Re: Tampa Electric Company, Polk Power Station

We have supplied, under separate cover, a submittal from Tampa Electric Company (TEC) concerning their Polk Power Station. That facility incorporates an IGCC electrical generating unit (GE 7FA), which combusts synthetic gas. As a result of the original permitting which was done, the BACT Determination for NO_x (only) was to be executed after the facility was operating for a period of time, such that test data was available. We are now commencing our review of this project.

FDEP Comment 3

APPENDIX BD - 2001

Figure 1

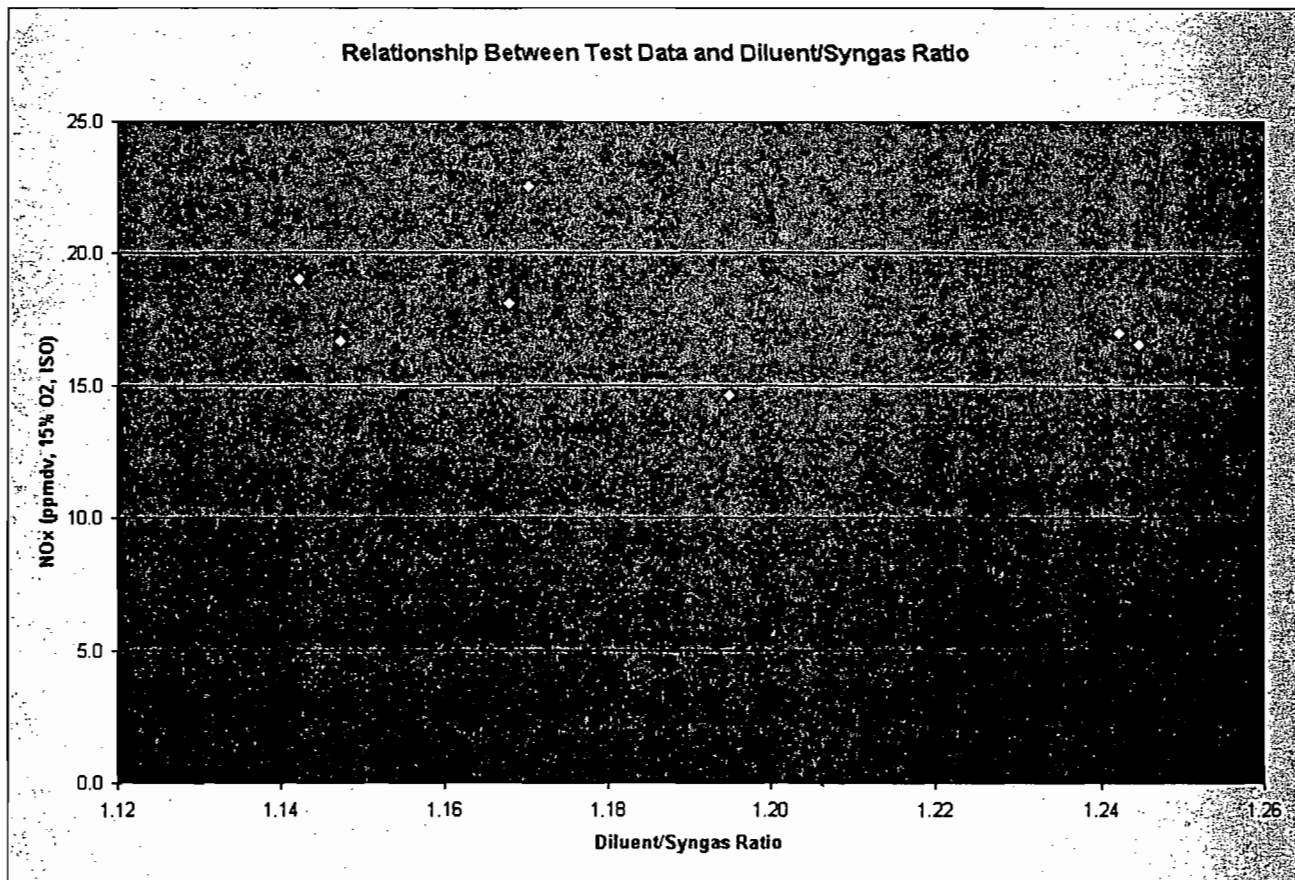
FDEP Comment 2

Please provide the average nitrogen diluent flow delivered to the CT during each of the seven NO_x BACT tests identified on page 4-1 of the submitted BACT analysis.

These data, presented graphically in the enclosed Figure 1, show no strong correlation between diluent/syngas flow rate and NO_x emissions rate. A linear regression analysis demonstrated a large error in fitting the data, with a regression coefficient of 0.14 thus, it may be concluded that factors other than the diluent/syngas flow ratio considerably affect the emissions performance of the combustion turbine.

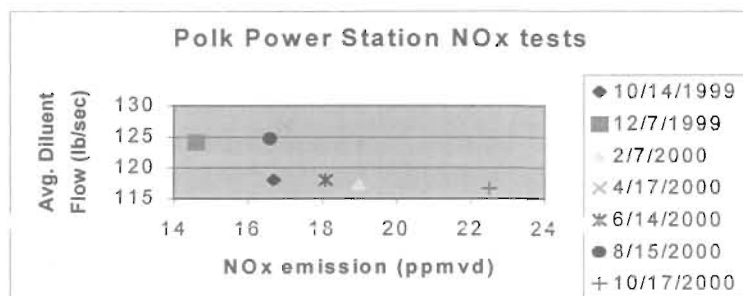
Applicant Comment: The cost to control NO_x emissions through the use of an SCR system on Polk Unit 1 presented in the analysis submitted to FDEP was based on a limited number of estimated costs. Since SCR has not been required for any IGCC installation in the United States, it is not possible to compare the cost of installing an SCR at the Polk facility to the cost of installing an SCR at another IGCC facility. The conclusion that SCR must be applied to Polk Unit 1 simply because the cost of NO_x control is lower than what the cost of NO_x control might be at the CPV Gulf Coast facility does not seem to take into account environmental, energy, and other costs as prescribed in the definition of BACT. In addition, this conclusion does not seem to consider the operation of 'other similar facilities' or 'manufacturer's research' as called for in Specific Condition A.50 of the Polk Power Station Title V Permit.

Department Response: It does not seem unreasonable to review the cost of applying an SCR to TEC's Polk Unit 1 (an IGCC unit) as it compares to the cost of applying an SCR to a gas/oil fired combined cycle unit. In fact, such a review leads to an initial conclusion that there is little difference in these costs.

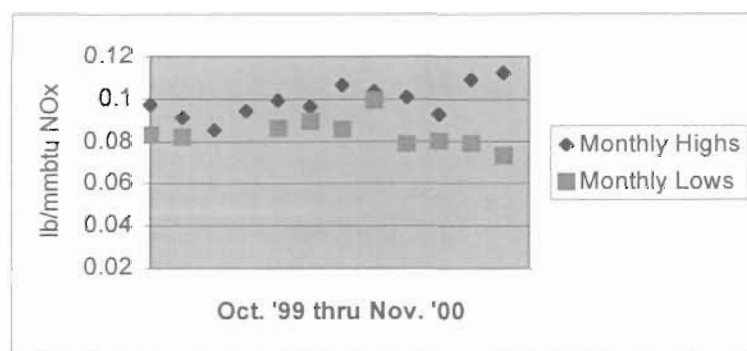
TEC has cautioned against an analysis of NO_x emissions as compared to diluent flow, noting that *“although the diluent flow is an important parameter for controlling NO_x emissions, a more appropriate measure is the ratio of diluent flow to syngas flow. On an overall basis, this ratio represents the proportional flows of NO_x controlling diluent and the syngas flow. Additional complicating factors that prevent a straightforward linear analysis of diluent flow rate or ratio and the NO_x emissions rate include the varying composition of the syngas, and the heating value of the fuel. Although these data are presented, TEC recommends against using these data to establish firm operating ranges due to the variability in other factors that significantly contribute to NO_x emissions from this combustion turbine.”*

Since diluent flow will likely increase with generating load (up to some load point) and since syngas flow is directly proportional to unit load, it is likely that a measure of diluent flow to syngas flow (which the applicant purports is more appropriate) makes some sense, as in the case of reviewing the entire load range of a combustion turbine. However, the Department wishes to better understand the impact of diluent flow on NO_x emissions, given that the diluent is the control media for NO_x. Since the tests are at a similar load point, the syngas flow and its associated variability can be effectively ignored. This yields a chart similar to the one above, indicating some level of correlation (albeit with 7 data points) between the diluent flow and NO_x emissions. Given the very limited amount of tests, one initial conclusion which might be drawn is that NO_x emissions are likely to be less than 19 ppmvd if the diluent flow is held to 120 lb/sec or higher.

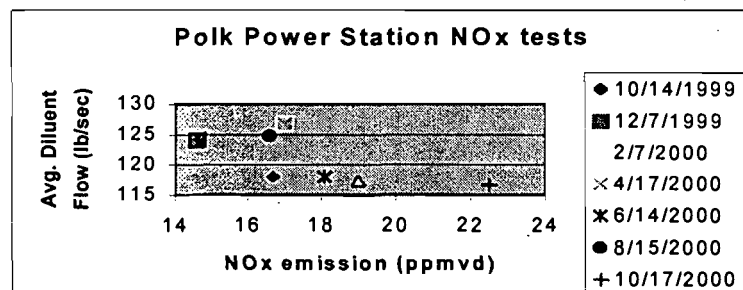
Applicant Comment: The cost to control NO_x emissions through the use of an SCR system on Polk Unit 1 presented in the analysis submitted to FDEP was based on a limited number of estimated costs. Since SCR has not been required for any IGCC installation in the United States, it is not possible to compare the cost of installing an SCR at the Polk facility to the cost of installing an SCR at another IGCC facility. The conclusion that SCR must be applied to Polk Unit 1 simply because the cost of NO_x control is lower than what the cost of NO_x control might be at the CPV Gulf Coast facility does not seem to take into account environmental, energy, and other costs as prescribed in the definition of BACT. In addition, this conclusion does not seem to consider the operation of 'other similar facilities' or 'manufacturer's research' as called for in Specific Condition A.50 of the Polk Power Station Title V Permit.

Department Response: It does not seem unreasonable to review the cost of applying an SCR to TEC's Polk Unit 1 (an IGCC unit) as it compares to the cost of applying an SCR to a gas/oil fired combined cycle unit. In fact, such a review leads to an initial conclusion that there is little difference in these costs.

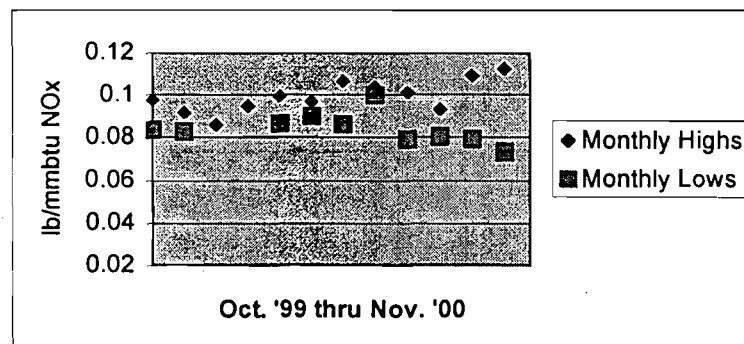
TEC has cautioned against an analysis of NO_x emissions as compared to diluent flow, noting that *“although the diluent flow is an important parameter for controlling NO_x emissions, a more appropriate measure is the ratio of diluent flow to syngas flow. On an overall basis, this ratio represents the proportional flows of NO_x controlling diluent and the syngas flow. Additional complicating factors that prevent a straightforward linear analysis of diluent flow rate or ratio and the NO_x emissions rate include the varying composition of the syngas, and the heating value of the fuel. Although these data are presented, TEC recommends against using these data to establish firm operating ranges due to the variability in other factors that significantly contribute to NO_x emissions from this combustion turbine.”* Since diluent flow will likely increase with generating load (up to some load point) and since syngas flow is directly proportional to unit load, it is likely that a measure of diluent flow to syngas flow (which the applicant purports is more appropriate) makes some sense, as in the case of reviewing the entire load range of a combustion turbine. However, the Department wishes to better understand the impact of diluent flow on NO_x emissions, given that the diluent is the control media for NO_x. Since the tests are at a similar load point, the syngas flow and its associated variability can be effectively ignored. This yields a chart similar to the one above, indicating some level of correlation (albeit with 7 data points) between the diluent flow and NO_x emissions. Given the very limited amount of tests, one initial conclusion which might be drawn is that NO_x emissions are likely to be less than 19 ppmvd if the diluent flow is held to 120 lb/sec or higher.

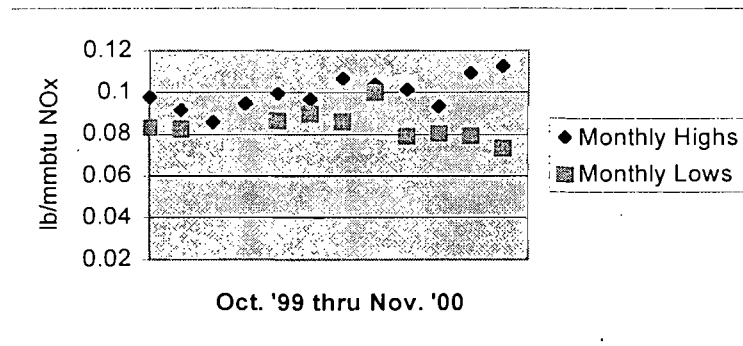
TEC has cautioned against an analysis of NO_x emissions as compared to diluent flow, noting that "although the diluent flow is an important parameter for controlling NO_x emissions, a more appropriate measure is the ratio of diluent flow to syngas flow. On an overall basis, this ratio represents the proportional flows of NO_x controlling diluent and the syngas flow. Additional complicating factors that prevent a straightforward linear analysis of diluent flow rate or ratio and the NO_x emissions rate include the varying composition of the syngas, and the heating value of the fuel. Although these data are presented, TEC recommends against using these data to establish firm operating ranges due to the variability in other factors that significantly contribute to NO_x emissions from this combustion turbine." Since diluent flow will likely increase with generating load (up to some load point) and since syngas flow is directly proportional to unit load, it is likely that a measure of diluent flow to syngas flow (which the applicant purports is more appropriate) makes some sense, as in the case of reviewing the entire load range of a combustion turbine. However, the Department wishes to better understand the impact of diluent flow on NO_x emissions, given that the diluent is the control media for NO_x. Since the tests are at a similar load point, the syngas flow and its associated variability can be effectively ignored. This yields a chart similar to the one above, indicating some level of correlation (albeit with 7 data points) between the diluent flow

and NO_x emissions. Given the very limited amount of tests, one initial conclusion which might be drawn is that NO_x emissions are likely to be less than 19 ppmvd if the diluent flow is held to 120 lb/sec or higher.
